Project	<b>IEEE 802.16 Broadband Wireless Access Working Group</b> < <a href="http://ieee802.org/16">http://ieee802.org/16</a> >	
Title	<b>H-ARQ support corrections, for OFDMA PHY mode</b>	
Date Submitted	<b>2004-04-24</b>	
Source(s)	<p>Panyuh Joo, Seungjoo Maeng, Jaeho Jeon, Soonyoung Yoon, Jeong-Heon Kim, Jaehyok Lee, Myungkwang Byun, Inseok Hwang, Jaehee Cho, Jiho Jang, Sanghoon Sung, Geunhwi Lim, Hong Sung Chang, Yong Chang, JungWon Kim, TaeWon Kim Samsung Electronics Co. Ltd.</p> <p>Yigal Leiba, Zion Hadad, Yossi Segal, Itzik Kitroser Runcom Technologies</p> <p>Choongil Yeh, Hyuongsso Lim, Yuro Lee, Jongee Oh, DongSeung Kwon, ETRI</p>	<p><a href="mailto:panyuh@samsung.com">panyuh@samsung.com</a></p> <p><a href="mailto:yigall@runcom.co.il">yigall@runcom.co.il</a></p> <p><a href="mailto:lim@etri.re.kr">lim@etri.re.kr</a></p>
Re:	Sponsor re-circulation Ballot	
Abstract	H-ARQ support corrections, for OFDMA PHY mode

Purpose	Adoption of proposed changes into P802.16-REVd/D4-2004	
Notice	This document has been prepared to assist IEEE 802.16. It is offered as a basis for discussion and is not binding on the contributing individual(s) or organization(s). The material in this document

**Figure 240—CTC encoder**

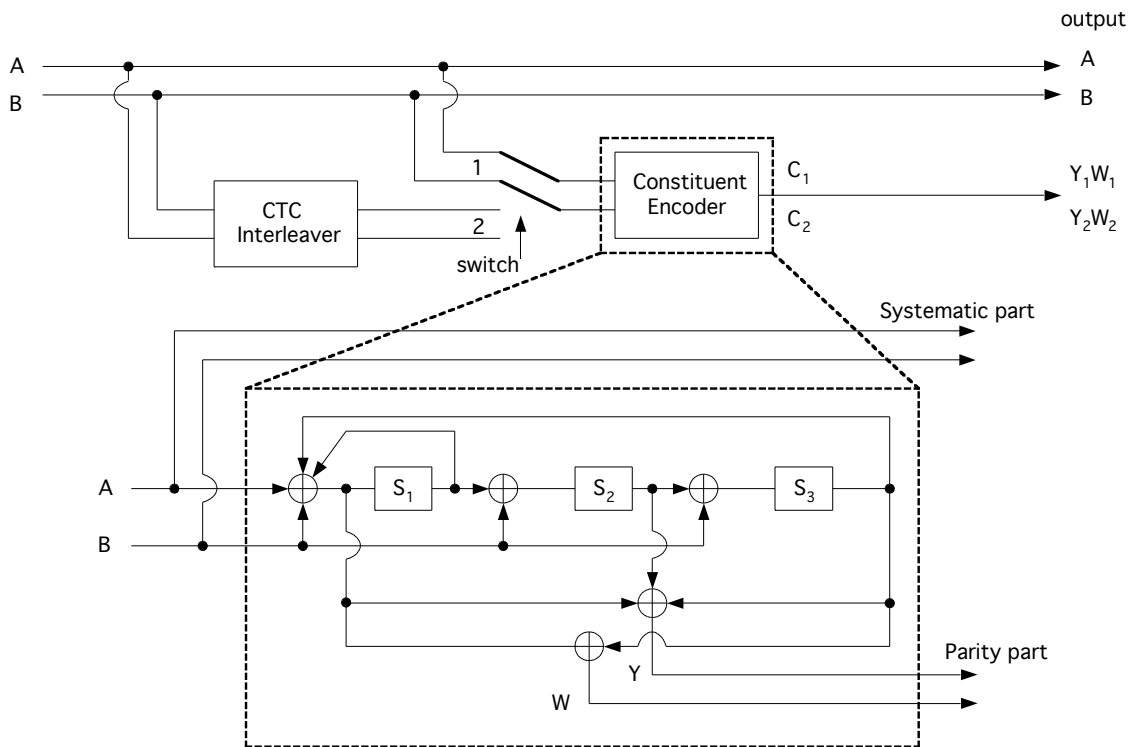
The Convolutional Turbo Code defined in this section is designed to enable support of hybrid ARQ (H-ARQ). H-ARQ implementation is optional. The Convolutional Turbo Code encoder, including its constituent encoder, is depicted in Figure 240. It uses a double binary Circular Recursive Systematic Convolutional code. The bits of the data to be encoded are alternately fed to A and B, starting with the MSB of the first byte being fed to A. The encoder is fed by blocks of k bits or N couples (k = 2\*N bits). For all the frame sizes k is a multiple of 8 and N is a multiple of 4. Further N shall be limited to: 8 ≤ N/4 ≤ 1024.

The polynomials defining the connections are described in octal and symbol notations as follows:

- For the feedback branch: 0xB, equivalently 1+D+D<sup>3</sup> (in symbolic notation)
- For the Y parity bit: 0xD, equivalently 1+D<sup>2</sup>+D<sup>3</sup>
- For the W parity bit: 0x9, equivalently 1+D<sup>3</sup>

**Figure 245— Block diagram of the interleaving scheme**

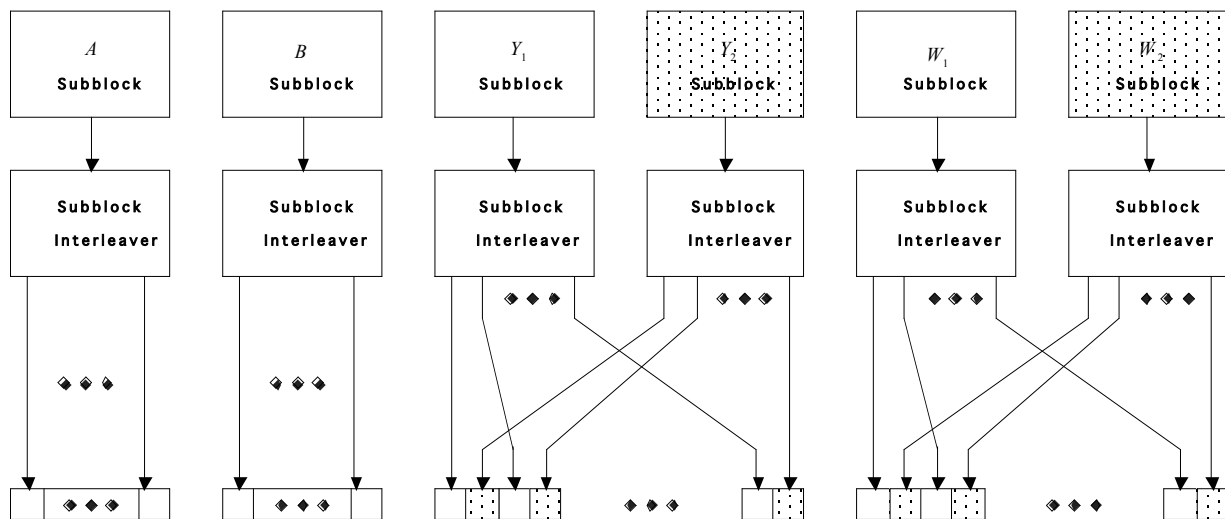
Proposed FEC structure punctures the mother codeword to generate subpacket with various coding rates. The subpacket is also used as H-ARQ packet transmission. Figure ~~bbb~~244 shows block diagram of subpacket generation. 1/3 CTC encoded codeword goes through interleaving block and the puncturing is performed. Figure 245 shows block diagram of the interleaving block. The puncturing is performed to select the consecutive interleaved bit sequence that starts at any point of whole codeword. For the first transmission, the subpacket is generated to select the consecutive interleaved bit sequence that starts from the first bit of the systematic part of the mother codeword. The length of the subpacket is chosen according to the needed coding rate reflecting the channel condition. The first subpacket can also be used as a codeword with the needed coding rate for a burst where H-ARQ is not applied.

**Figure 245—Block diagram of the interleaving scheme**

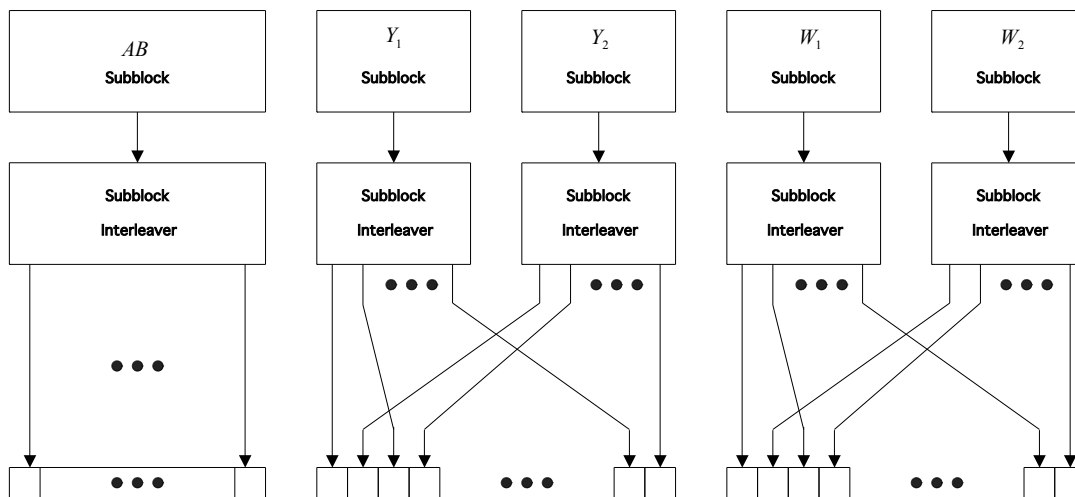
Figure eec245 shows block diagram of the interleaving scheme of the proposed FEC structure. At first, the CTC encoder output is separated into a subblock. Then the interleaving is applied for the bit sequence within the subblock. It guarantees the uniformity of the interleaved codeword. Next, Symbol grouping is performed such that the parity bits from the two constituent encoders are interleaced bit by bit. The systematic part of the 1/3 CTC encoder is located at the head of the interleaved codeword. In this way, the proposed FEC structure ensures the quasi-complementary characteristics of the interleaved codeword and thus, complementary characteristics of the subpacket. We just say "quasi-complementary" for the case of breaking the complementariness of few bits after puncturing.

**Figure eee – PRBS of the randomizer**

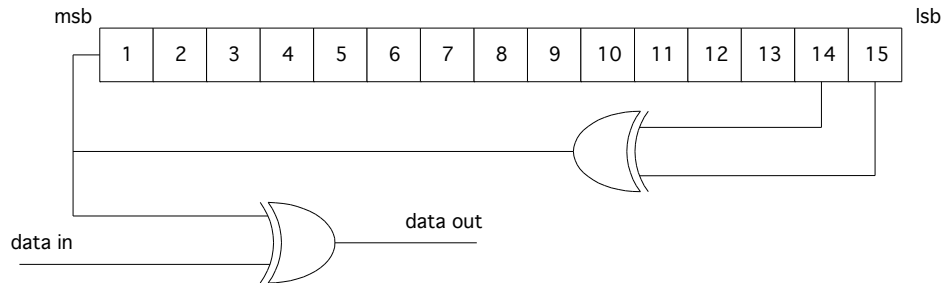
The Pseudo Random Binary Sequence (PRBS) generator shall be  $1 + X^{14} + X^{15}$  as shown in Figure eee. Each data byte to be transmitted shall enter sequentially into the randomizer, MSB first. The seed value shall be used to calculate the randomization bits, which are combined in an XOR operation with the serialized bit stream of each burst. The randomizer sequence is applied to the output from the padding block. The bit issued from the randomizer shall be applied to the CRC encoder.

**Figure fff – Initialization construction for the PRBS of the randomizer**

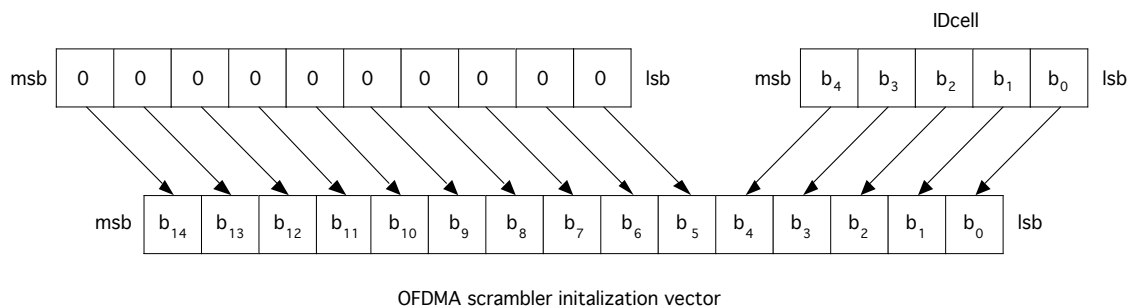
The scrambler is initialized with the vector created as shown in Figure fff. The lowest 5 bits are ID<sub>cell</sub> or UL\_ID<sub>cell</sub> and the other bits are set '0'.

Figure 125—Construction of H-ARQ encoder packet

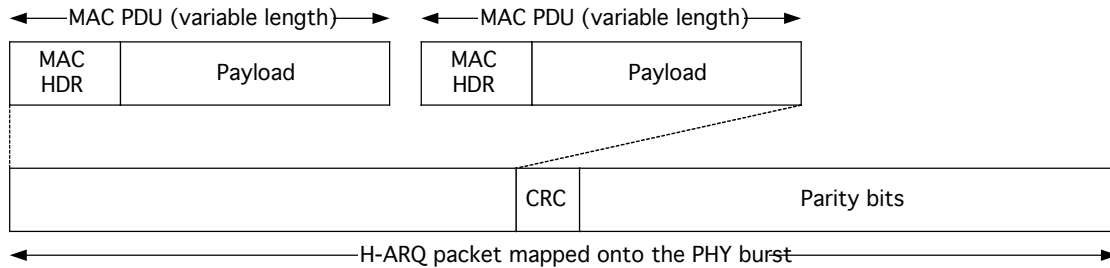
One or more MAC PDUs can be concatenated and an H-ARQ packet formed by adding a CRC to the PHY burst. Figure 125 shows how the H-ARQ encoder packet is constructed.

Figure 1 Reduced CID Decoding

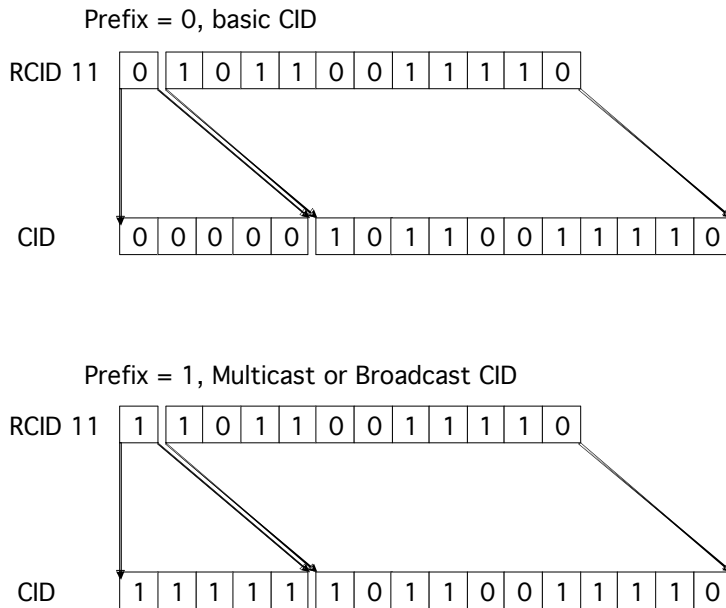
Figure 1 shows the decoding of reduced CID when the RCID\_Type is set to 3.

Figure 2 Subchannel allocation modes of Compact DL-MAP\_IE for Band AMC

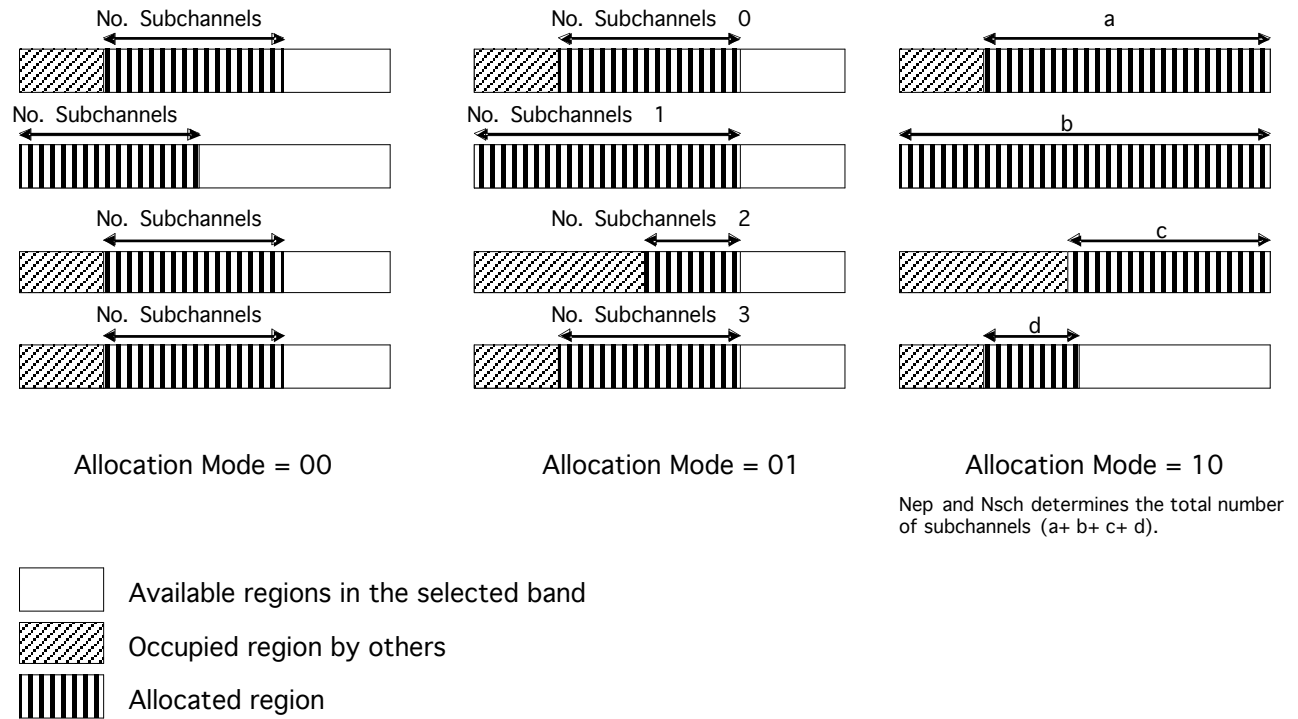
[The allocation mode variant is shown in Figure 2.](#)
